Landscape Statement of Common Ground

In Respect of: Land East of Oxhey Lane, Carpenders Park

PINS Ref: APP/P1940/V/26/3378268 | LPA Ref: 25/1020/OUT

Application ref: 25/1020/OUT
Location: Land East of Oxhey Lane, Oxhey Lane, Carpenders Park, Hertfordshire
Proposal/Description: Outline planning application for up to 256 homes (C3 use class) (including affordable and self/custom build housing), housing with care (C2 use class), a children's home (for looked after children) (C2 use class) together with associated access (including off-site highway works), parking, open space and landscaping (appearance, layout, landscaping and scale as reserved matters)

Visual context

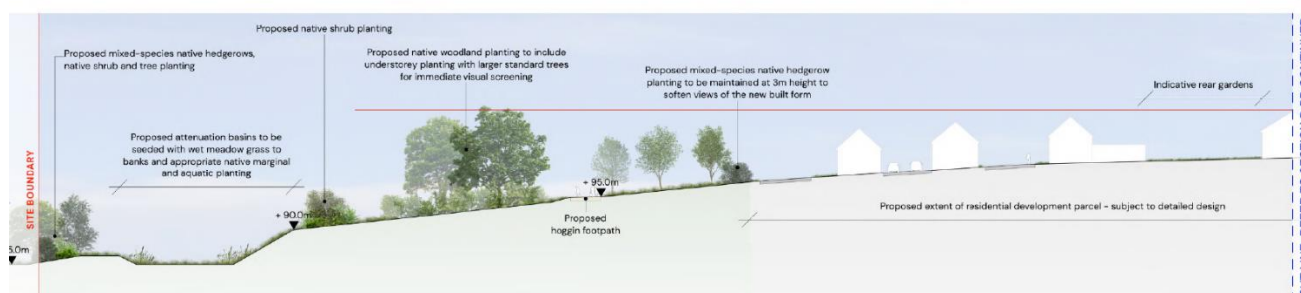
The relationship between the site and the built edge of settlement is not questioned. But we consider that the site also has a visual connection with the rural landscape with views to the south from the mid and southern site parcels, although we acknowledge these are not publicly accessible locations. The LVIA has recognised open views to the west and panoramic views southeast.
